# MUNICIPAL COMPLEX

## SCHEMATIC DESIGN COST ESTIMATE

**THE TOWN OF SHALLOTTE**

APRIL 30, 2025

## PROPOSED REVISED ELEVATIONS

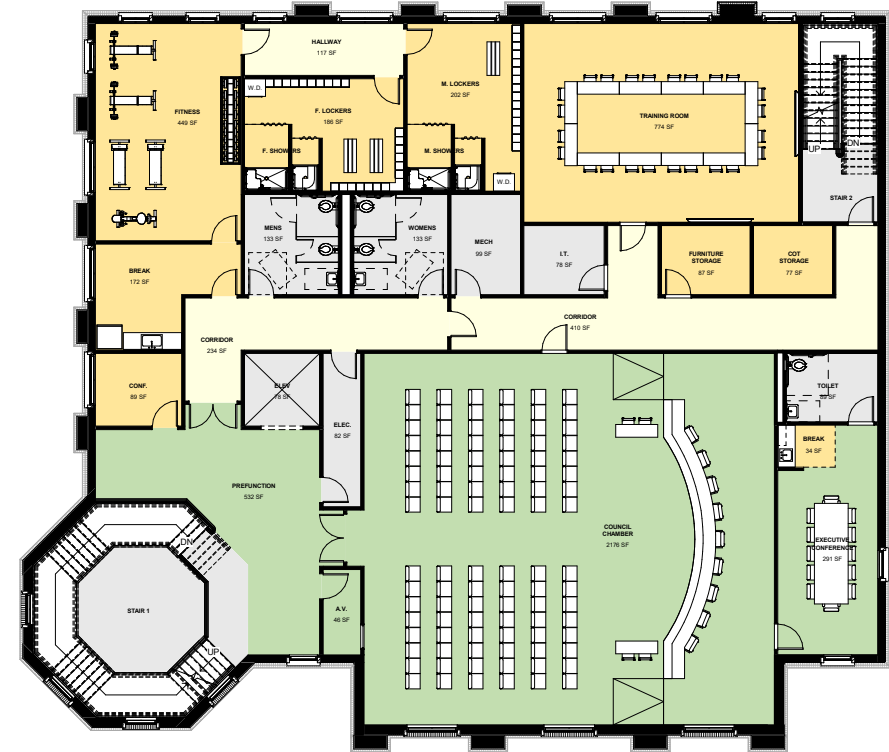
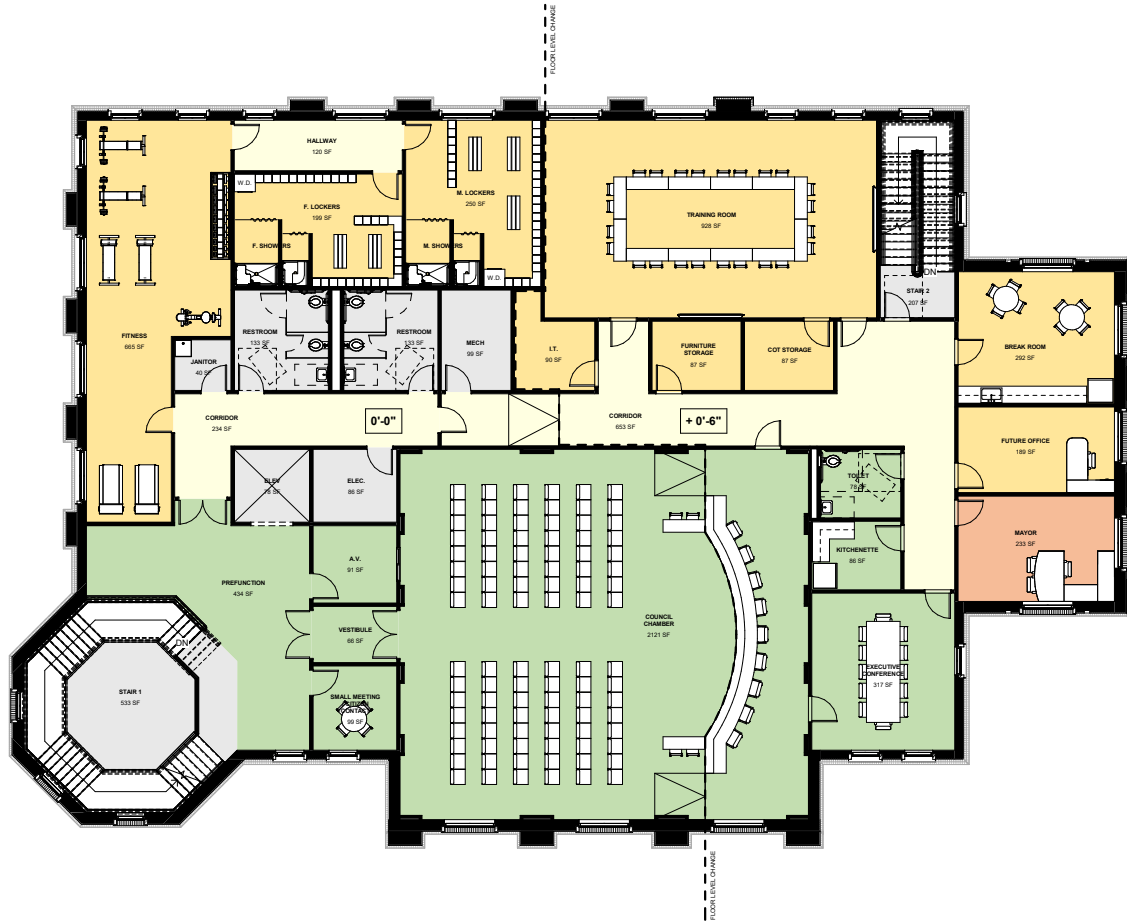
- Floor to floor heights have been reduced by two feet at first and second floors
- Size of glazed openings have been reduced to maintain proportions with the revised floor to floor heights
- The amount of brick and decorative brackets on the exterior have been reduced. The proposed revision still includes brick at the first floor and primary features on two street facing facades
- Proposed cost saving opportunities to the electrical and mechanical systems while maintaining required functionality for the EOC and critical facility operations
- Reduced height and size of the lighthouse at the stair tower. This also proposes a prefab "lantern" in lieu of the previous design to be built in place with building materials consistent with the remainder of the building
- Ornamental metal site fence at site perimeter in lieu of masonry

THIRD FLOOR - 8,016 SQUARE FEET

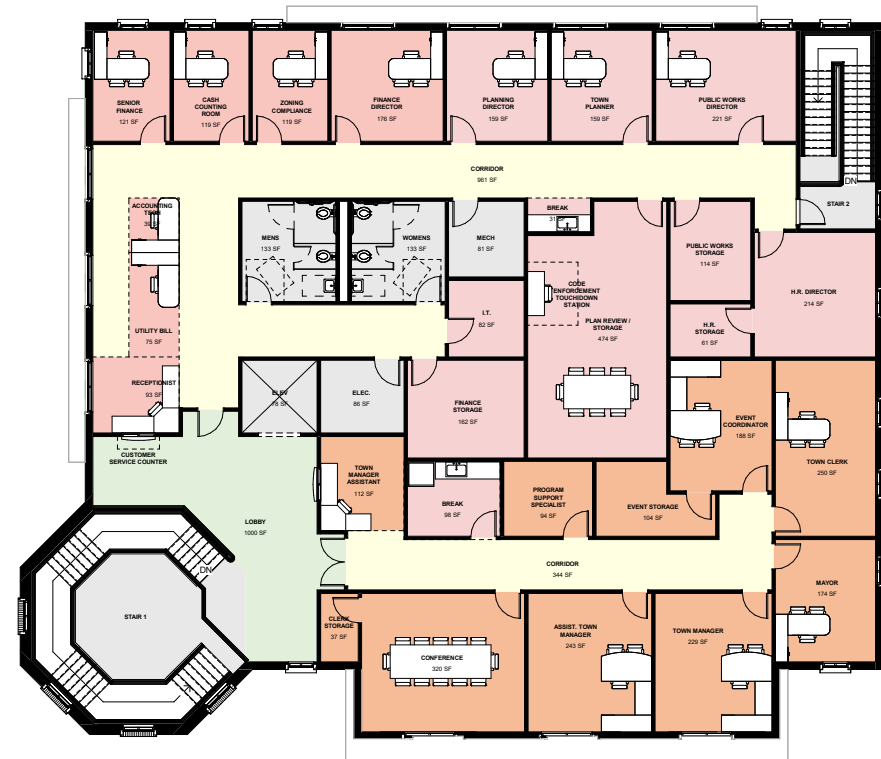
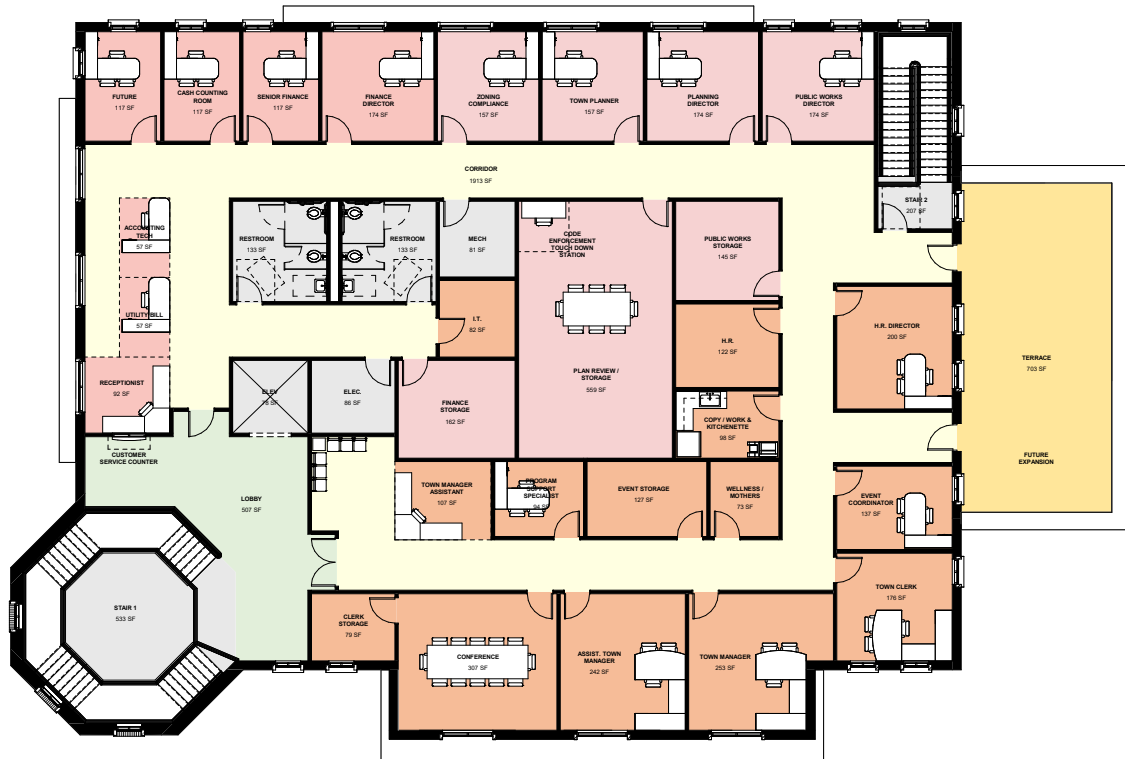
- This design incorporates all cost savings from "Option 2" as well as a reduced footprint
- Total facility reduced from 29,063 square feet, which represents the extent of the program from the original 2023 study, to 24,174 square feet
- Secure fence and gate system in lieu of fully enclosed Sally Port with balcony on 3rd Floor
- Reduced brick further on all facades

## REVISED ELEVATION "OPTION 2"

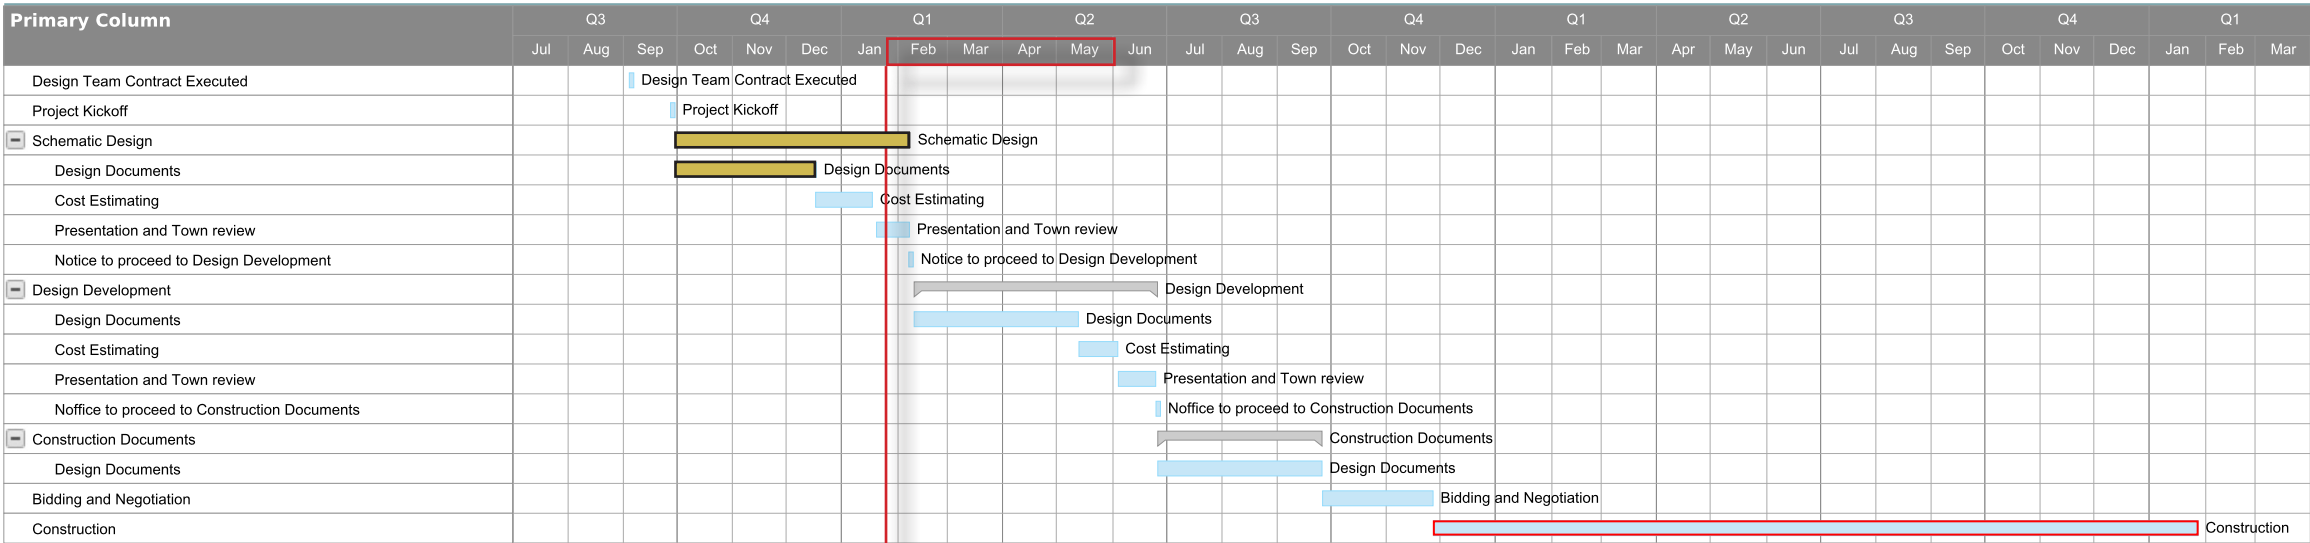
- Floor to floor heights have been reduced by two feet at first and second floors
- Size of glazed openings have been reduced to maintain proportions with the revised floor to floor heights
- The amount of brick and decorative brackets on the exterior have been reduced. The proposed revision still includes brick at the first floor and primary features on two street facing facades
- Proposed cost saving opportunities to the electrical and mechanical systems while maintaining required functionality for the EOC and critical facility operations
- Reduced height and size of the lighthouse at the stair tower. This also proposes a prefab "lantern" in lieu of the previous, built in place with building materials consistent with the remainder of the building
- Ornamental metal site fence at site perimeter in lieu of masonry
